SUBJECT: VOIDED APPLICATION

Control Number: 88852

Applicant: Ohio State University

We have reviewed your application dated March 5, 1990 for a new wet source storage irradiator and find that we will need the following information in order to complete your request.

Figure 9-2: Plan View of Nuclear Reactor Laboratory (Not To Scale)

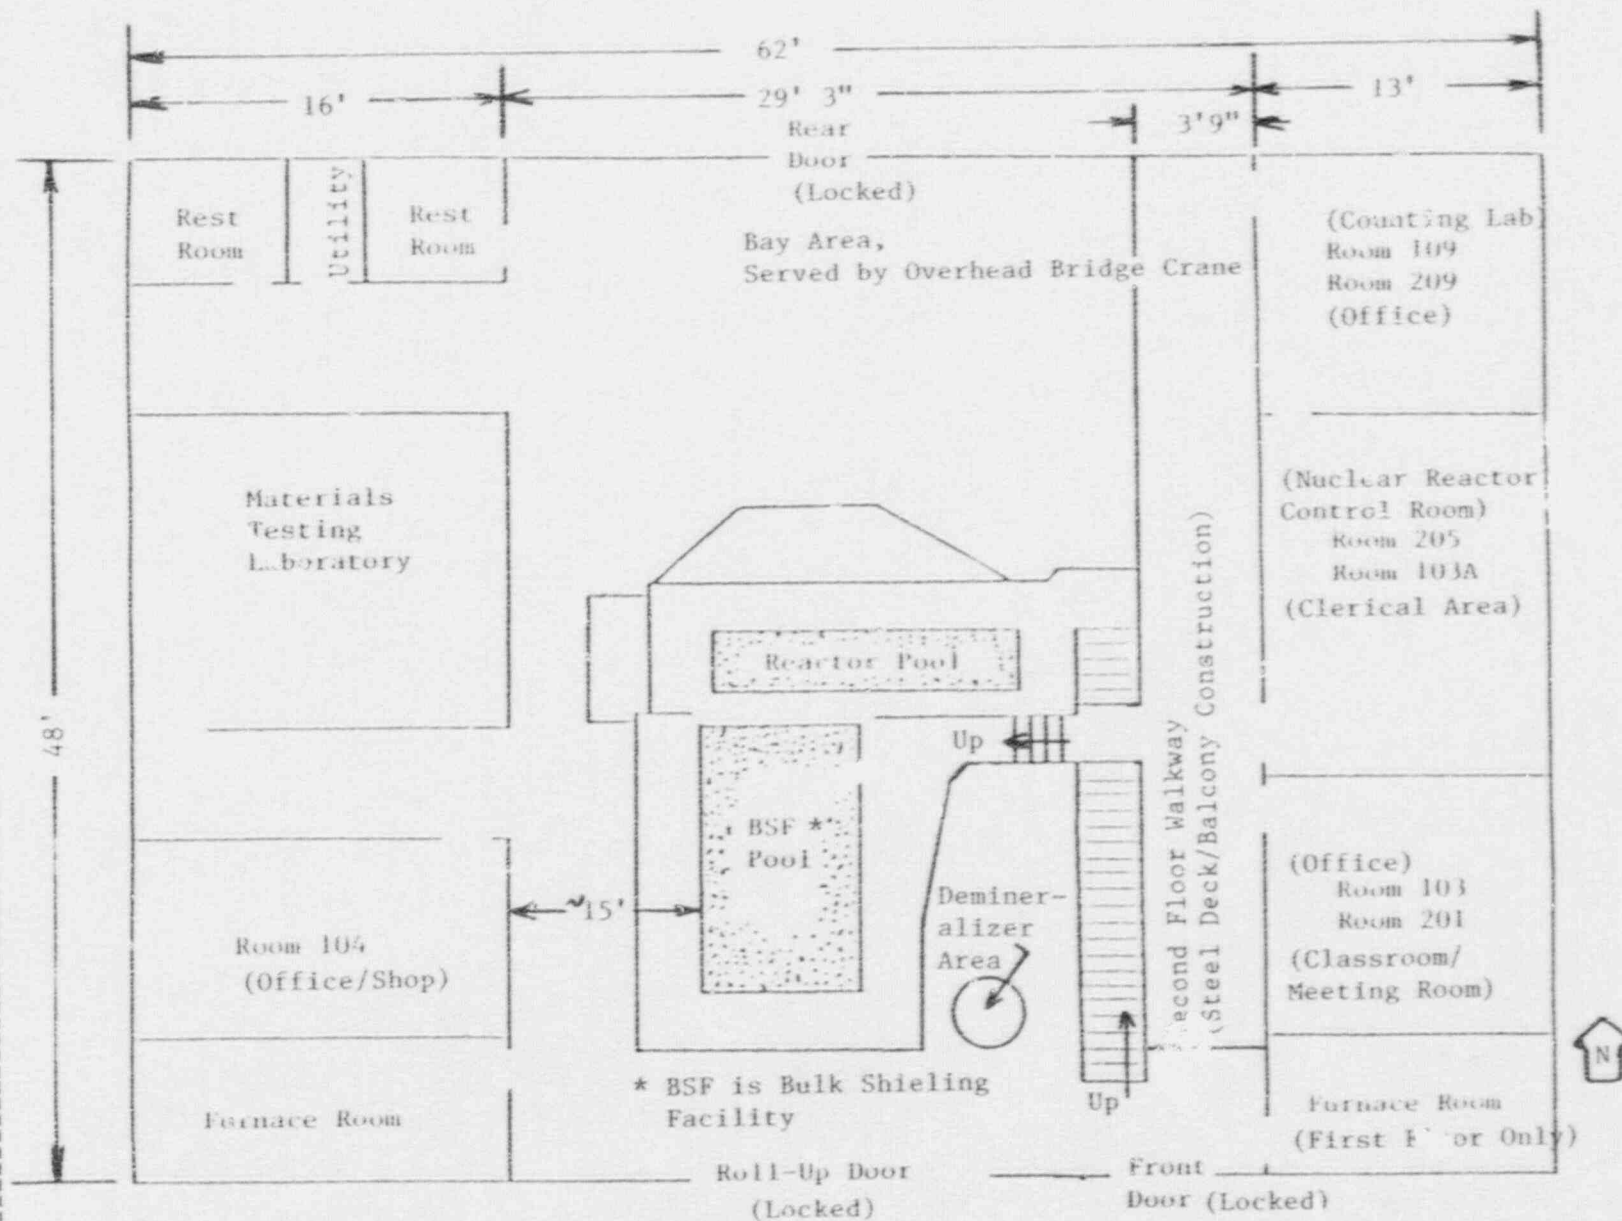
Another channel of the area radiation monitor system measures the radiation level in the vicinity of the demineralizer. (Refer to Figure 9-2.)

Section 9.2 of our original application, as well as Figure 9-2, refer to a pool "demineralizer". This demineralizer is a mixed-resin, ion exchanger. Further, the survey instruments available at the Nuclear Reactor Laboratory are listed in Appendix C of the original application.
